10/767,537

Greg Smith

Office Action Summary

Claims 1, 2 and 12 are rejected under 35 U.S.C. 102(b) as being clearly anticipated by **Ng** (6,474,810).

FIG. 2

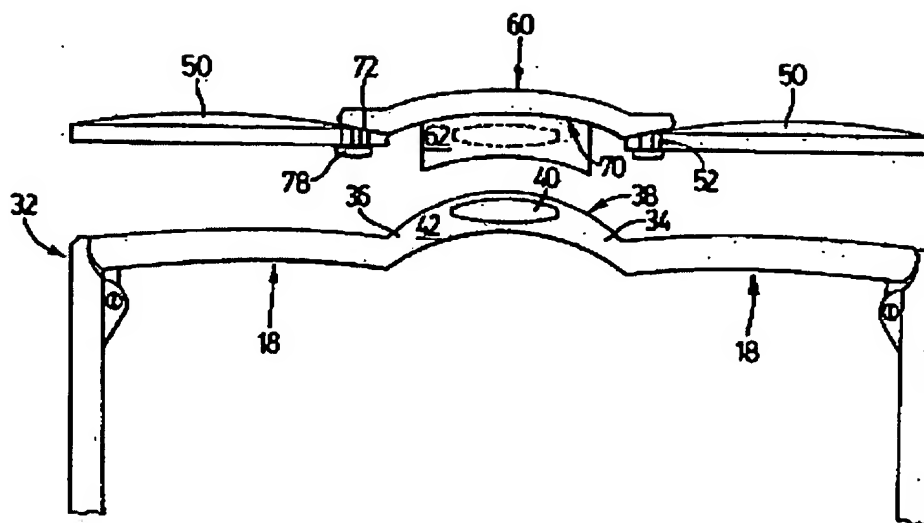
Ng discloses bridge for attaching auxiliary lenses which comprises a primary lens assembly 32 comprising a primary bridge 34 attached between primary lenses, an auxiliary lens assembly comprising 20, an auxiliary bridge 60 attached between auxiliary lenses 50, and the flange 36 on the front of the primary bridge, the auxiliary bridge 60 having an expandable clip (upper projection 62 and lower projection 64); and, whereas the clip of the auxiliary bridge 60 is expandable to engage the bridge of the primary bridge 34, further comprising: a leg portion 44 attached to each primary lens; a flange 36 on the front of the primary bridge 34, and whereas the clip is expandable onto the flange whereas the flange 36 is locatable in the clip in a complimentary fit of their respective cross-sectional perimeters, a protrusion 66 located on the auxiliary bridge, whereas the projection is a spherical segment, a projection 66 located on the auxiliary bridge, a complementary relief 40 located on the flange 36, whereas the protrusion 66 is

locatable in the relief 40 when the clip is located on the flange and the flange 36 having a radiused end 38 and the clip having an interior radius 70, the radiused end 38 of the flange 36 being locatable in the interior radius 70 of the clip in a tight fit (complimentary fit) of their respective cross-sectional perimeters (at least see figure 2 and column 4, lines 34-41.)

Applicant argued that Ng does not teach the radiused end 38 of the flange 36 being locatable in the interior radius 70 of the clip in complimentary fit of their respective cross-sectional perimeters.

As show in figure 2 and column 4, lines 34-41 above, the radiused end 38 of the flange 36 being locatable in the interior radius 70 of the clip in a tight fit (complimentary fit) of their respective cross-sectional perimeters. Therefore, the claimed invention does not distinguish over the Ng (6,474,810).
